BREZZA LOFTS MIXED USE

DESIGN DEVELOPMENT DRAWINGS
11/05/2025

CONSTRUCTION DRAWINGS FOR:
BREZZA LOFTS - WARD FARM TOWN CENTER PHASE 1
SWANSBORO, NC 28584

UNIT TYPE C

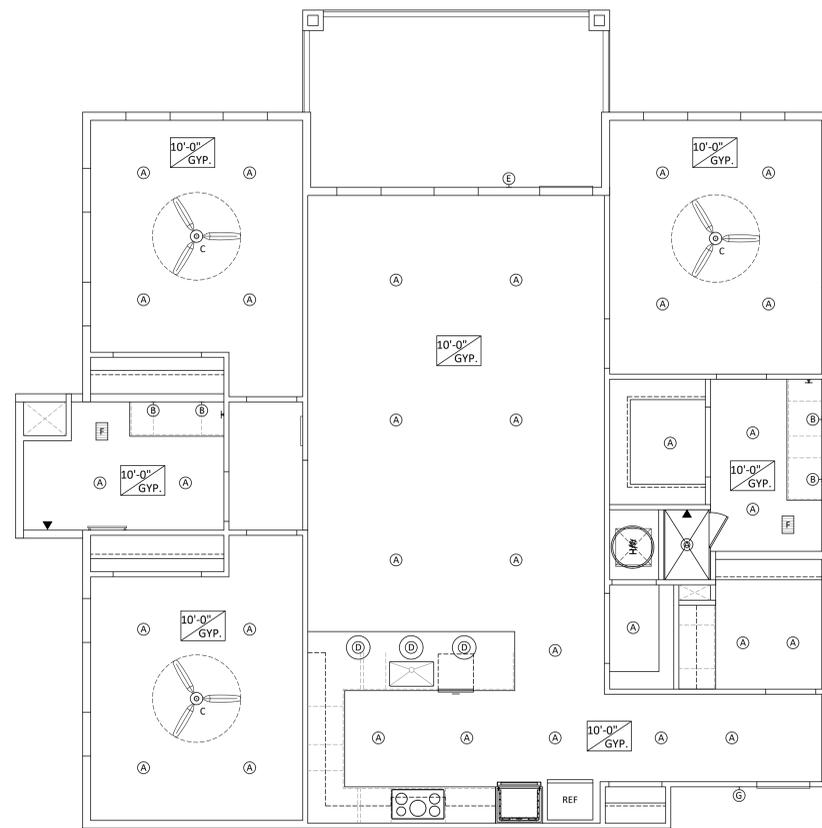
redline where you want outlets and stuff
